Staff Report

Report To: City Council
Report From: Sabine Robart, Intermediate Planner
Meeting Date: August 26, 2019
Report Code: CS-19-107
Subject: Recommendation Report Respecting Zoning By-law
Amendment No. 28 and Site Plan Approval ST2018-016
1200 16th Avenue East (API Hotel)

1 WEST ELEVATION
A301 1/8" = 1'-0"

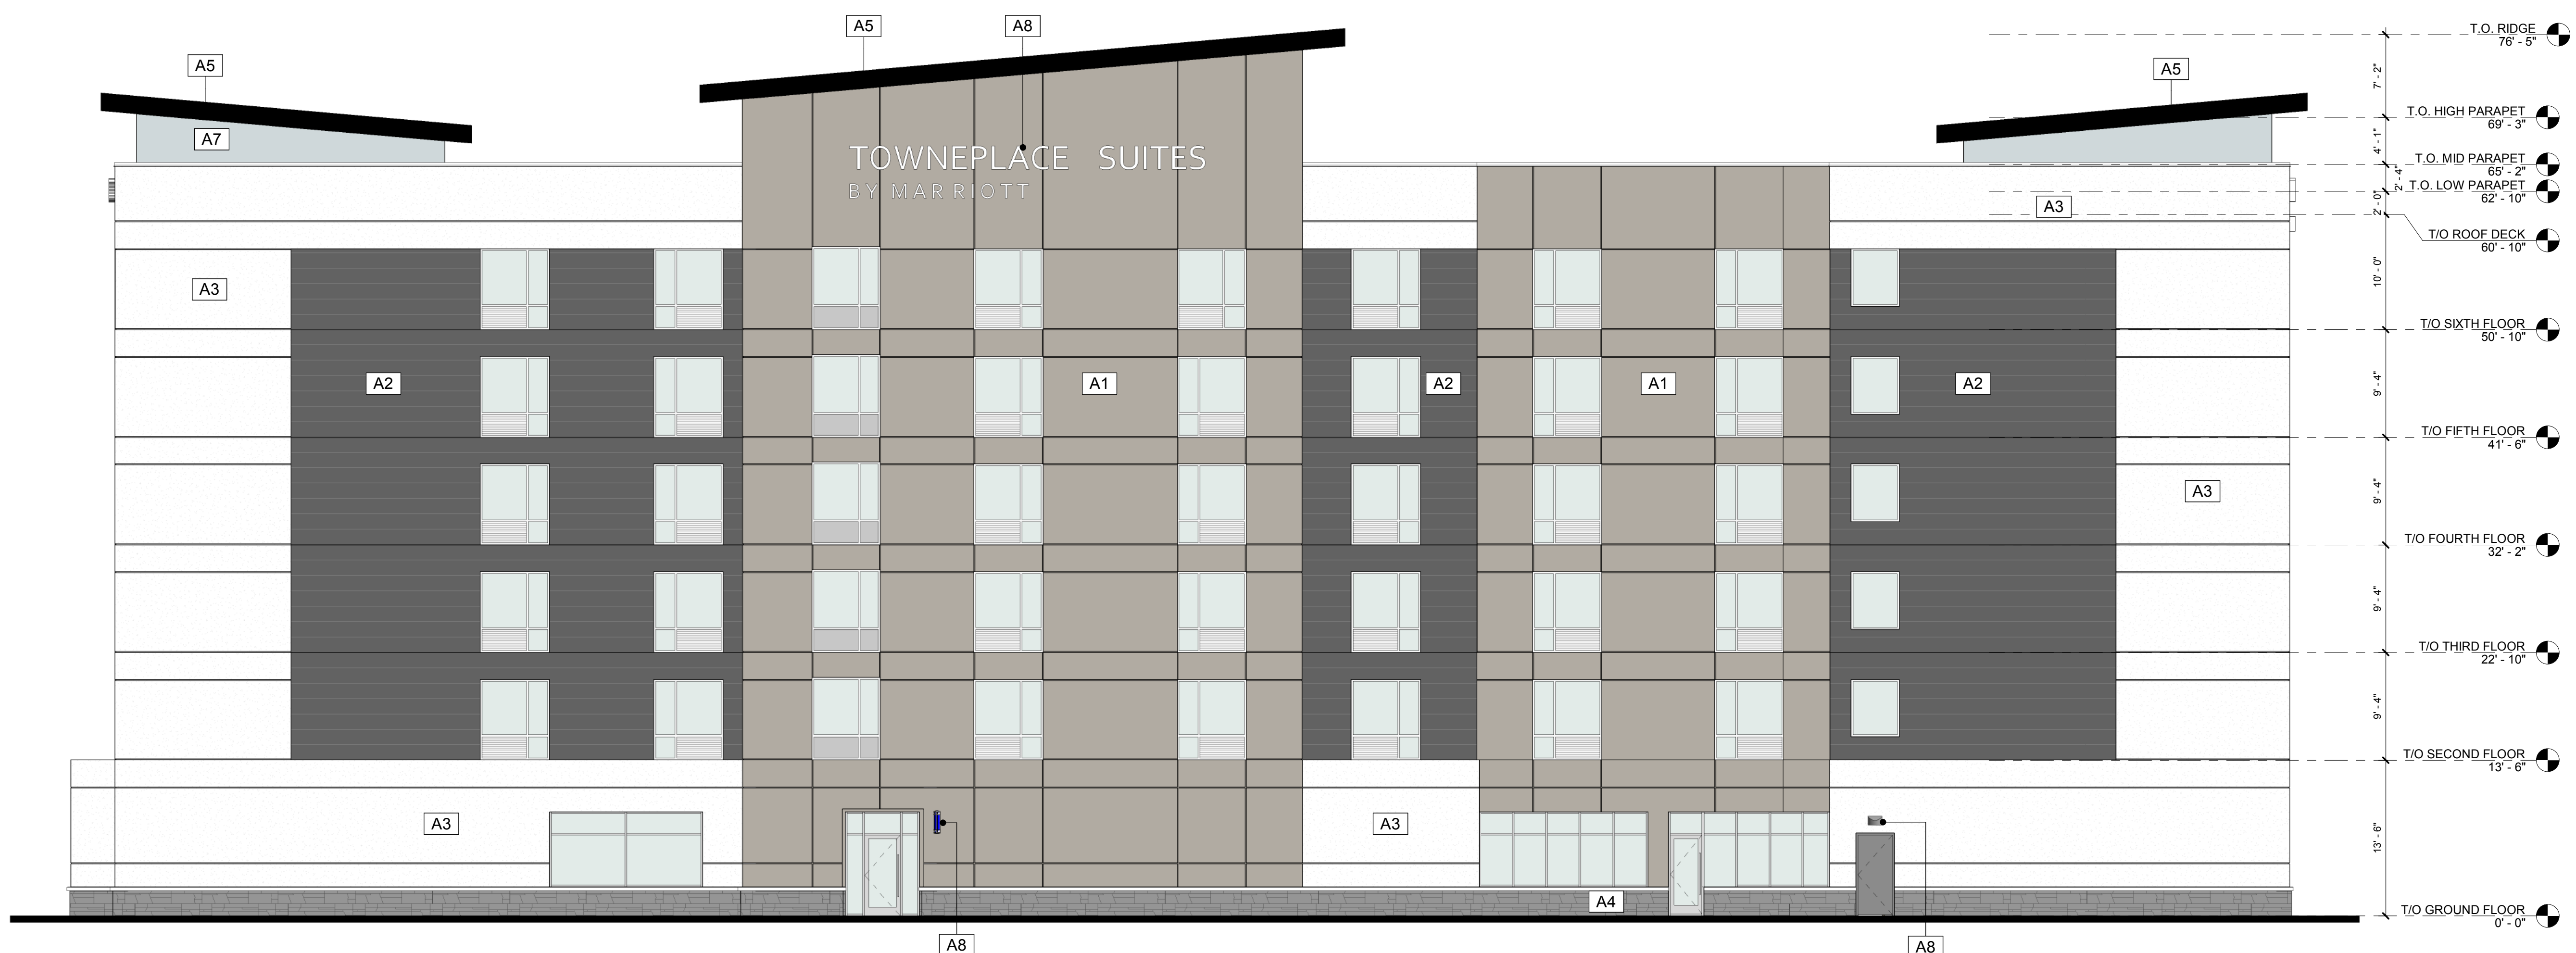
The functional height increase for the flat roof of the hotel is minimal, however, the hotel design includes a decorative parapet wall. At its tallest point the parapet is proposed to be 4.8 m in height (Schedule D – Proposed Elevations). The parapet proposed for the hotel roof will provide architectural interest to the building and will minimize the visual impact of any mechanical equipment on the roof of the building. From an urban design standpoint, this is positive. The Zoning By-law definition of ‘Building Height’ requires that the highest point on a flat roof, excluding mechanical equipment, be accounted for in the building height measurement. The height of the parapet accounts for the majority of the requested height increase. The design and height of the parapet varies along the roof line and the maximum parapet height does not occur across the full façade of the building thereby reducing the potential impact of the increased height. As noted above, the shadowing study indicates minor shadow impact on adjacent properties for a relative short time. The proposed hotel height increase from 18 m to a maximum of 23.3 m for the parapet wall is believed to meet the general intent and purpose of the Zoning By-law.
